Re: Birdsboro Power, LLC
Consumptive Use
Birdsboro Borough and Exeter and Robeson Townships, Berks County, Pennsylvania
DOCKET NO. D-2016-004-1

DRN has reviewed BP's proposed docket and we submit these comments:

Figure 1: Instantaneous Measure of Discharge: Schuylkill River at Reading

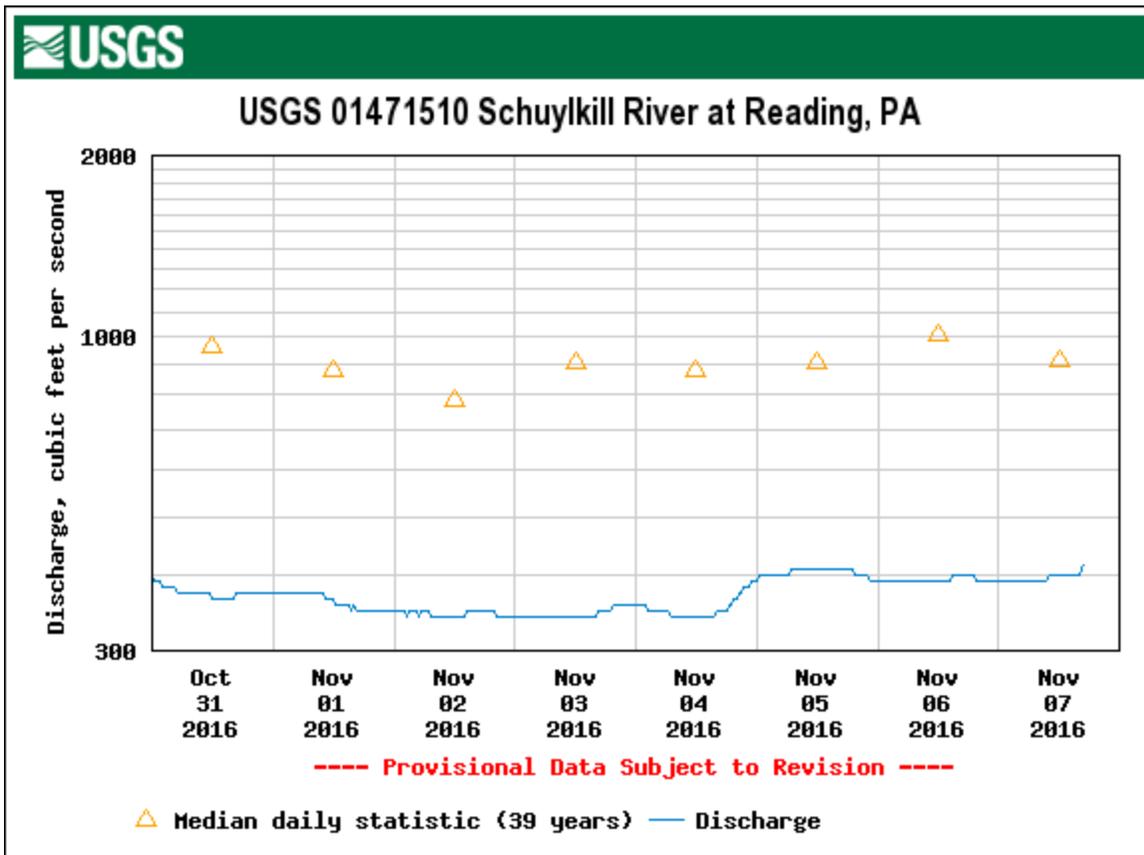
Current flow levels in the Schuylkill River underscore the need to consider alternatives to drinking water for consumptive uses. The instantaneous measure of discharge, as measured at 17:00 EST, was 417 cubic feet per second (see image below). This figure is below the 25th percentile for November 7th, based on statistics for 39 years of record, and less than half the median.¹⁶

Table 2: RAWA's daily average withdrawals from 2002 through 2016

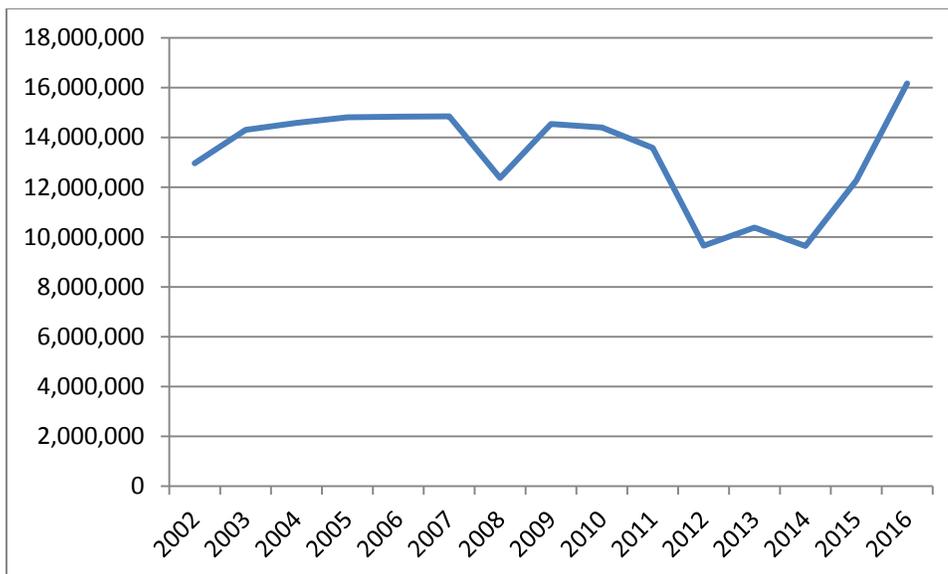
DRN also questions the decision to use the mean to determine RAWA's daily average withdrawals from 2002 through 2016. Using the mean to determine RAWA's daily average would be more appropriate in a large dataset with no outliers. By contrast, for the period from 2002 to 2016 there are just 15 numbers which do appear to include outliers. In only three of 39 years of data were RAWA's daily average withdrawals under 10 MGD, but two of those years are included in the 2002 to 2016 dataset. DRN notes that for the period 2002 through 2016, the mean with the two outlier years removed, and with a projected increase in average water demand of 0.5%, would be approximately 13.9 MGD.

With RAWA's daily average withdrawals ranging from 9.6 MGD to 16.1 MGD in just 15 years of data the more appropriate measure of RAWA's daily average withdrawals would have been the median. For the period 2002 through 2016, the median, with a projected increase in average water demand of 0.5%, would be approximately 14.4 MGD. The median for the full 39 years of record, without any projected increase in average water demand, would be 14.8 MGD. DRN recommends that a new water availability study be undertaken using the median rather than the mean to determine a value for modeling RAWA's daily average withdrawals.
